City Planning Commission
Sacramento, California

SUBJECT: 1631 O Street and 1416 17th Street, Priority Structure rehab and New construction; CADA; (PB85-035)

**Subject: 1631 O Street, Priority Structure - Renovation, Residential/Garage -
New Construction**

DESIGN REVIEW & PRESERVATION BOARD
1231 "T" Street - SACRAMENTO, CALIFORNIA 95814

FIRST FLOOR PLAN

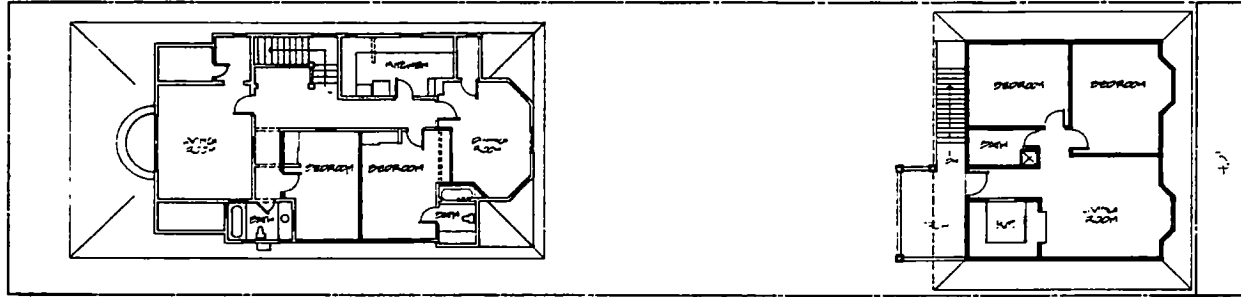
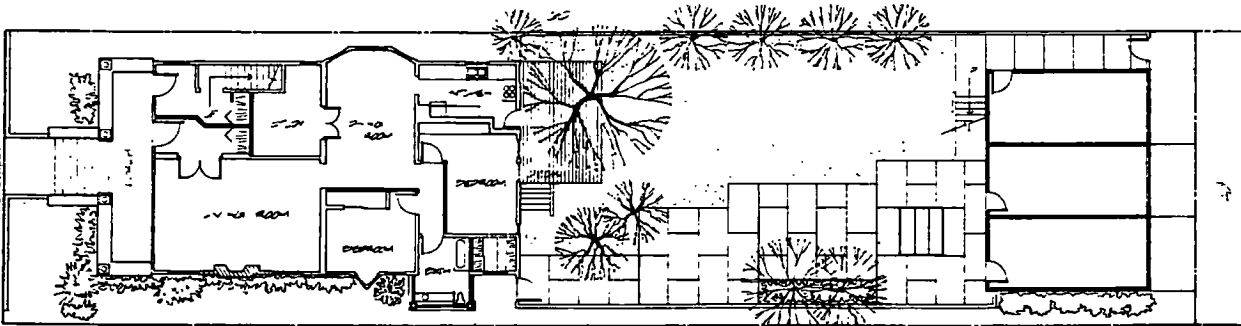
1. ~~Existing Structure~~ Exterior changes will not be as extensive as in Proposal 2. An additional front entrance is intended for the new upstairs unit. A deck is proposed at the rear.
2. ~~New Structure~~ The materials and roof design reflects that of the existing structure. Only one elevation is provided. Staff is concerned with the adequacy of the other elevations.

The new single unit proposal will utilize only a portion of the existing rear yard. As opposed to Proposal 2, which will utilize most of the existing rear yard, Proposal 1 would more closely conform with the Design Review Board's previously indicated preference that the vacant rear portion of the site remain as yard area.

SEVENTEENTH STREET ELEVATION

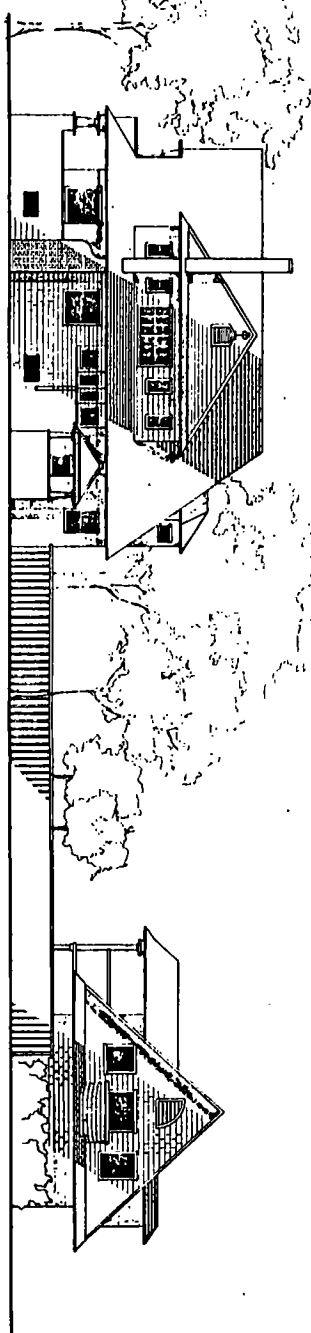
Staff finds the alley access to this unit undesirable. Preferably, a gate on 17th Street would be provided and the foot of the stairs relocated accordingly. The gate on the alley would become less of a private entrance for the new unit and more of a shared access for all the tenants.

3. ~~Fencing~~ The fencing along the 17th Street frontage is located within the five foot required setback area. The proposed six-foot height would comply with City fencing regulations only as a wrought iron fence. A fence of wood or other material has a height limit of three feet within the setback area. A six-foot wood fence is permitted outside the setback area.

1. The multi-pane windows should not be used in that they are incompatible with the building's period of architecture; and
2. The fence should be designed more as a picket fence or similar relief should be provided along the top of the fence to be compatible with the Listed Structure.

17th STREET ELEVATION

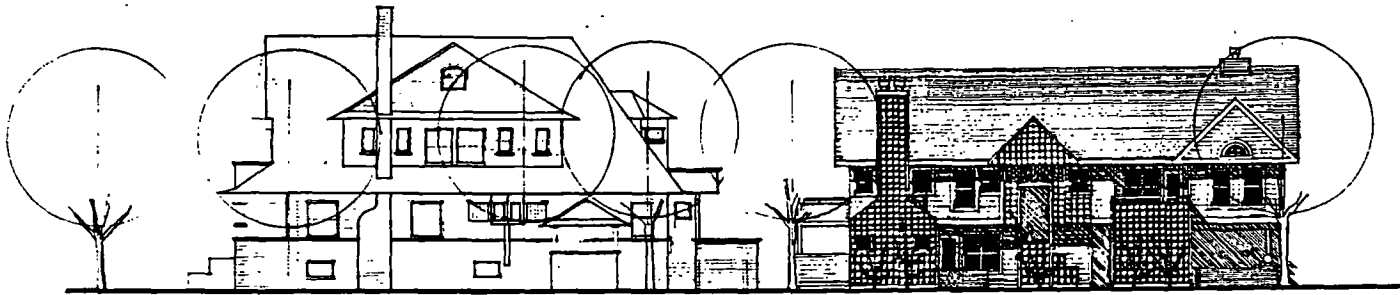
The structure is designed to complement the existing structure but not to repeat its use of materials or its architectural details. The latter and the larger scale of this design as opposed to Proposal 1 will contribute to an appearance as an independent development.

The structure is a good deal of visual interest. However, it is concerned with the openness of the parking to view from the street. Also, depending upon the type of lighting to be used, signs from the property may be apparent from the street.

The street side wall set back of the living room would be only 1.5 feet rather than the required two feet. The latter above the stairs to the second floor will also reduce the live foot setback.

3. The materials on the west elevation of the new structure shall match those proposed on the other side of the building. The east elevation shall be modified to remedy the encroachment into the setback of the lattice above the stairway.

4. The applicant shall attempt to lessen the visibility from the street into the carport parking area.
5. The west elevation and revised east elevations shall be submitted to the Design Review staff for review and comment.

SITE PLAN AND FIRST FLOOR PLAN

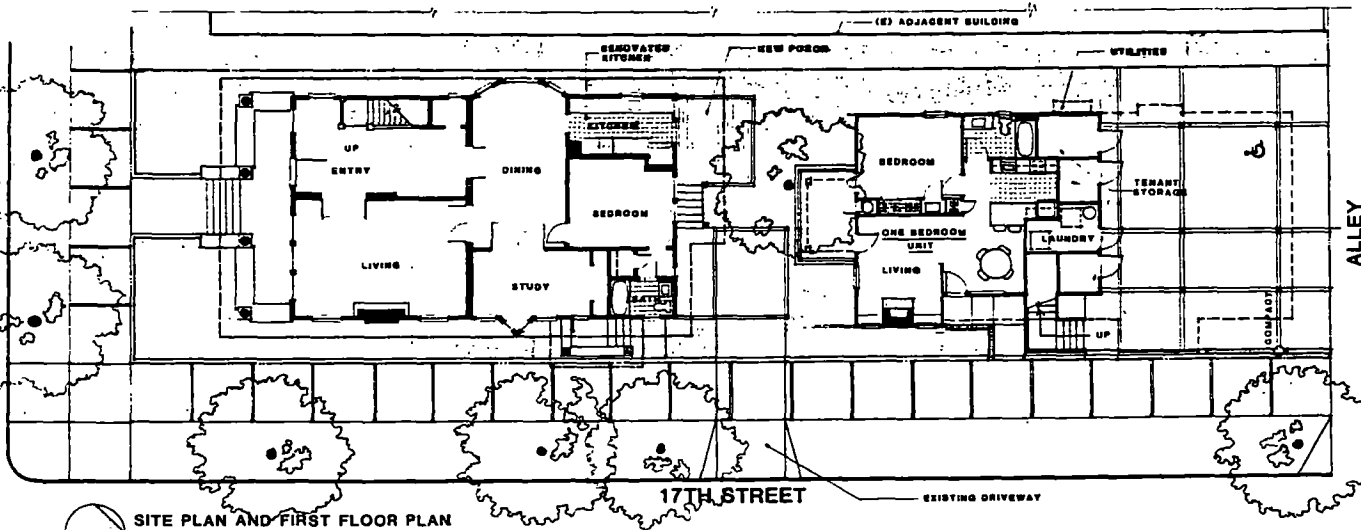
2. Two porches - The proposed new three unit structure will utilize most of the existing rear yard however, as previously indicated, it would include a higher density of development as specified for the area in City and County plans.

The separation of the two buildings, between their balconies, will need to be at least six feet.

3. With the proposed higher density of use, an enclosed trash storage area should be provided.

6. The separation of the two buildings, between their balconies, shall be at least six feet.
7. A large tree in the rear yard shall be retained.
8. An enclosed or screened trash storage area shall be provided.
